SUBJECT:	Gold Seal Harness
REASON FOR BULLETIN:	To Inform Users of New Part Numbers For the New TCM Gold Seal Harnesses, Leads and Spare Parts, Interchangeability With Dura-Blue Harness Hardware and New Procedures For Gold Seal Assembly
EQUIPMENT AFFECTED:	Harnesses and Leads For TCM (Bendix) S-20, S-200, S-1200, D-2000, D-3000 Series Magnetos and Slick 4200 and 6200 Series Magnetos

TCM IGNITION SYSTEMS

SERVICE BULLETIN NO.635

FIGURE 2: POSITIONING OF BRAID ON EYELET, CUTAWAY VIEW

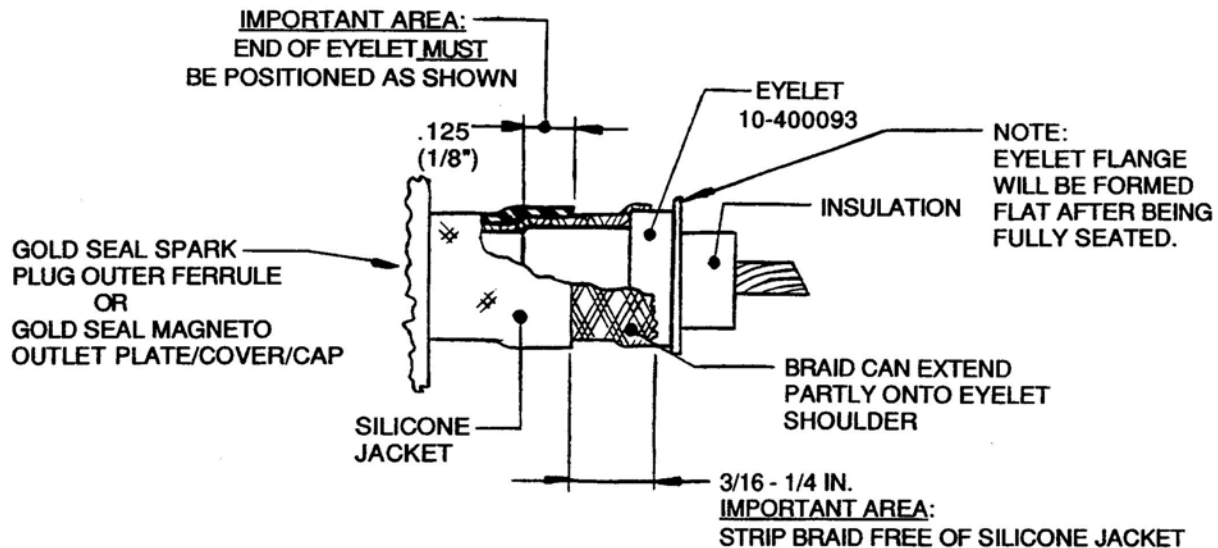
- a. Insure 3/16 inch of silicone jacket is stripped from end of shielding as shown in Figure 2.
- b. Insert P/N 10-400093 Eyelet under braiding to position shown in Figure 2.
- c. Pull cable with correctly positioned eyelet into ferrule or outlet and fully seat using a suitable pressing tool. See Figure 1) for pressing tool dimensions.

FIGURE 3: 3/4-20 SPARK PLUG TERMINAL PARTS INTERCHANGEABILITY

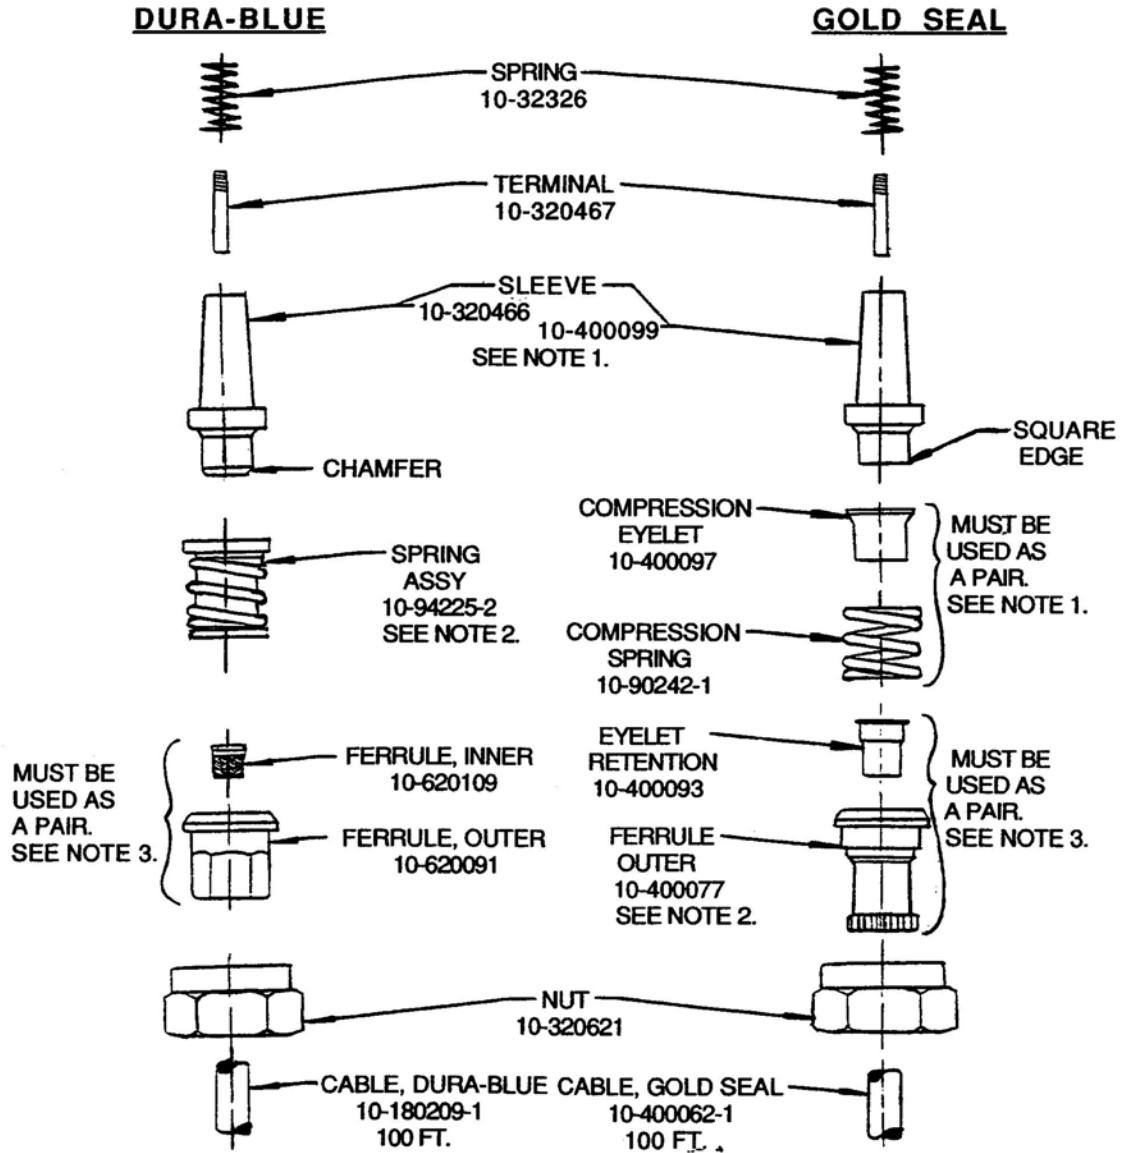
- 1) Sleeve 10-320466 cannot be used with Eyelet 10-400097. Otherwise, indicated sleeves and spring arrangements are interchangeable.
- 2) May be used with 10-400112-8 or -12 Bend Clamp Kit. See Figure 7.
- 3) Parts may be interchanged as a pair. Dura-Blue or Gold Seal Cable may be used with either Ferrule & Eyelet arrangement.

FIGURE 4: 5/8-24 SPARK PLUG TERMINAL PARTS INTERCHANGEABILITY

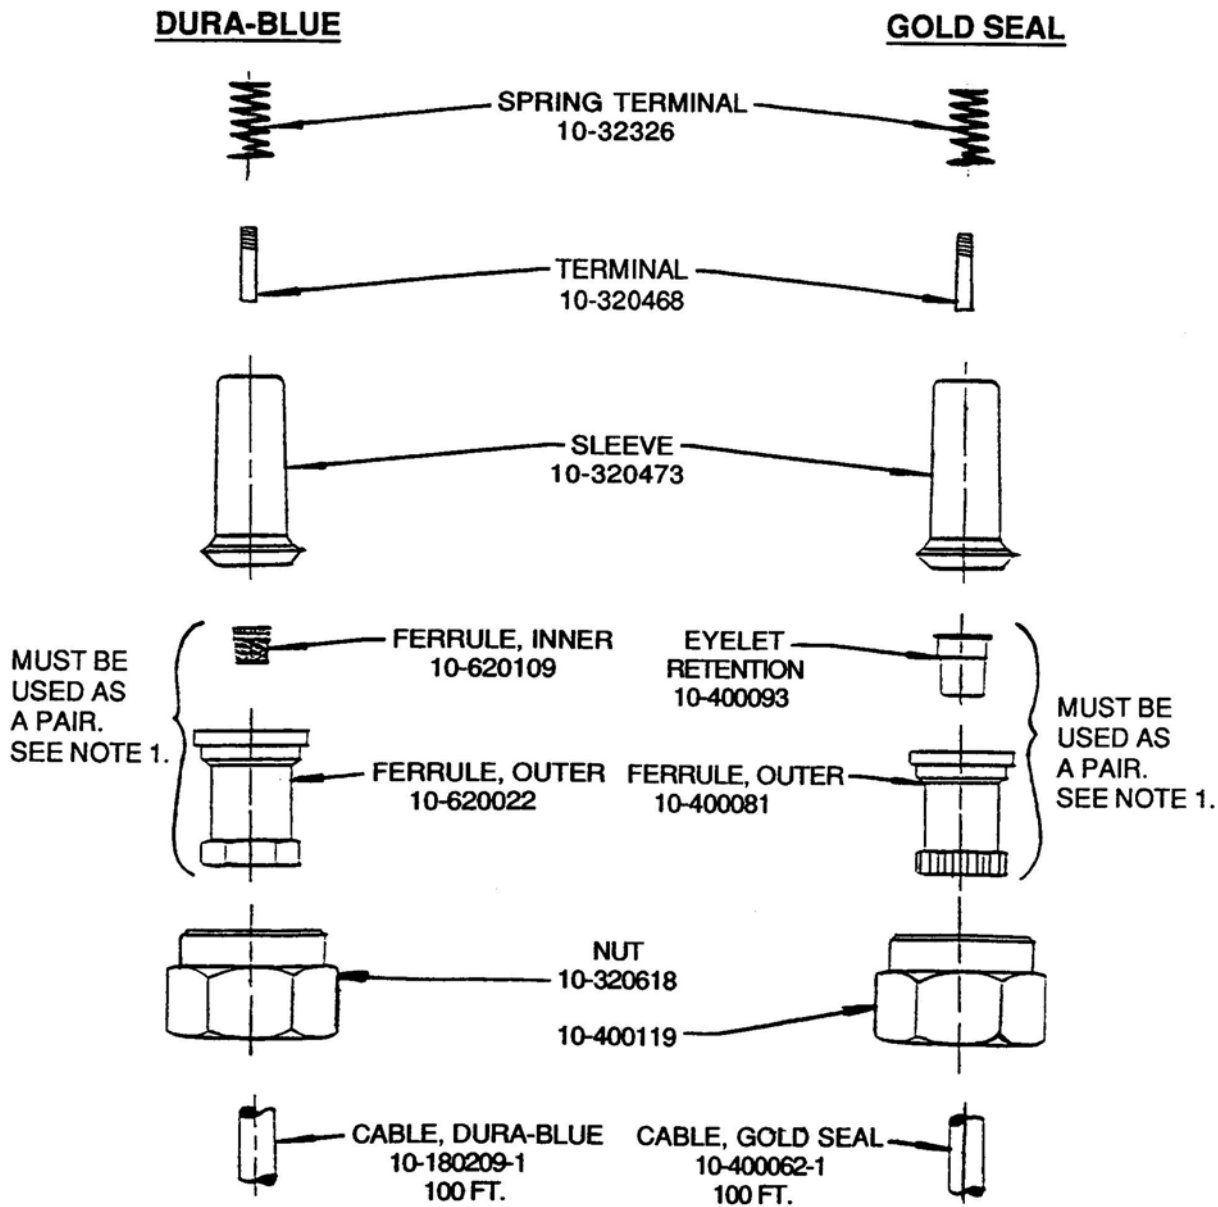
- 1) Parts may be interchanged as a pair. Dura-Blue or Gold seal Cable may be used with either Ferrule and Eyelet arrangement. Either outer Ferrule may be used with 10-400112-8 or -12 Bend Clamp Kit. See Figure 7.

FIGURE 5: TCM (BENDIX) MAGNETO OUTER PLATE PARTS INTERCHANGEABILITY

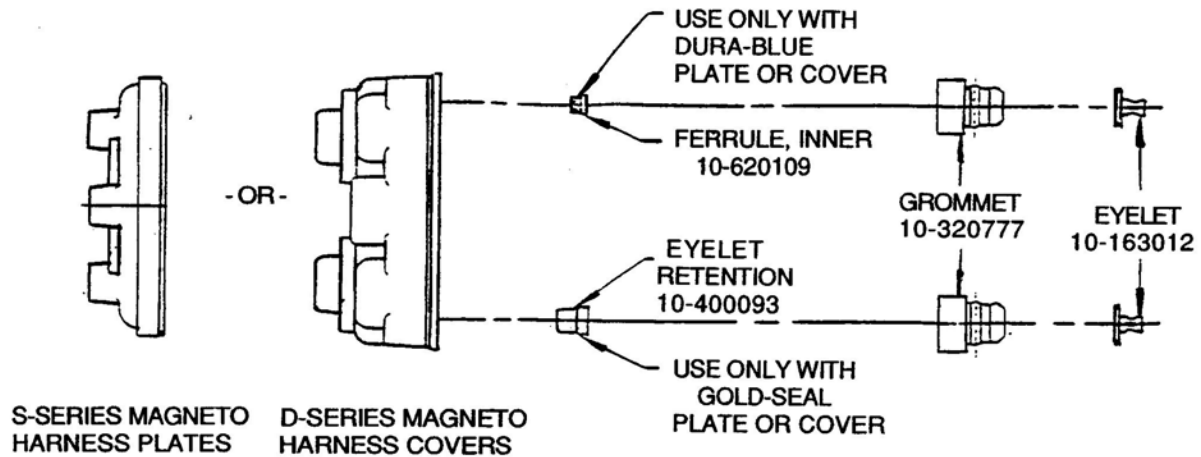
- 1) Current Dura-Blue Plates/Covers are marked with "••" (older units are not marked). Use with 10-620109 Ferrule only.
- 2) Gold Seal Plates/Covers are marked with "TCM Gold Seal". Use with 10-400093 Retention Eyelet only.
- 3) Interchangeability of TCM Gold Seal Harness parts with any other brand of Harness parts is not guaranteed.
